Stannah Lifts Technical Bulletin

Issue No: M14

LIFT TYPE:- Homelift - Reduced Headroom.

Refer drawing HD3037 Minimum Head Room (attached).

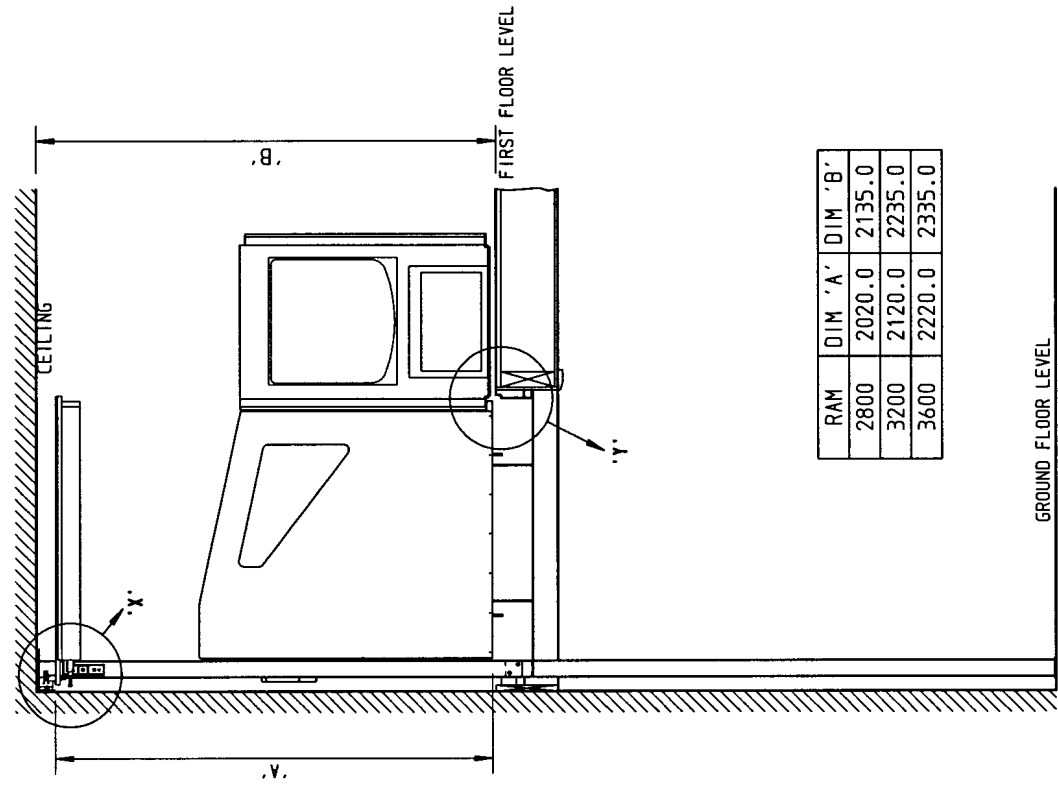
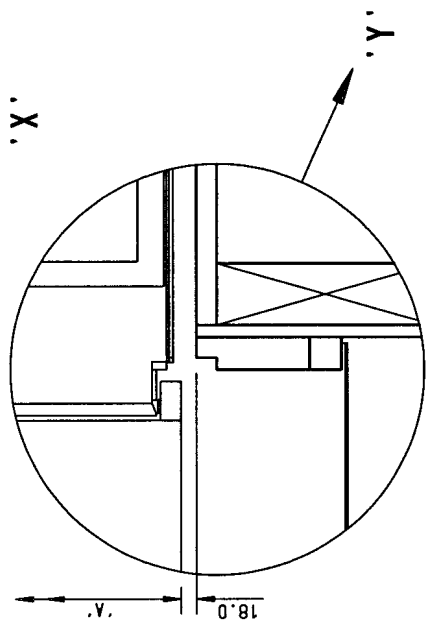
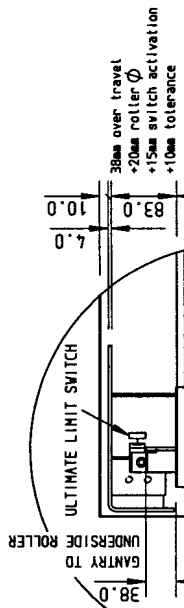
It has come to our attention that in some instances a reduced headroom would be helpful to enable the Homelift to be installed in a wider range of properties.

New headroom clearance at first floor level will be.

2135mm (2800 ram)	Existing 2220mm
2235mm (3200 ram)	Existing 2320mm
2335mm (3600 ram)	Existing 2420mm

These dimensions have been achieved by taking the following dimensions and clearances.

From first floor level.

10mm Carpet.
8mm strips under door.
2020mm (2120/2220) car/gantry and gantry leg depth.
75mm over travel (this includes 38 over travel, 20mm switch roller diameter and 15mm switch activation = 73mm)
10mm building/car tolerance.
4mm Top beam thickness.

10mm Clearance from top beam to ceiling for installation.

Total headroom = 2137
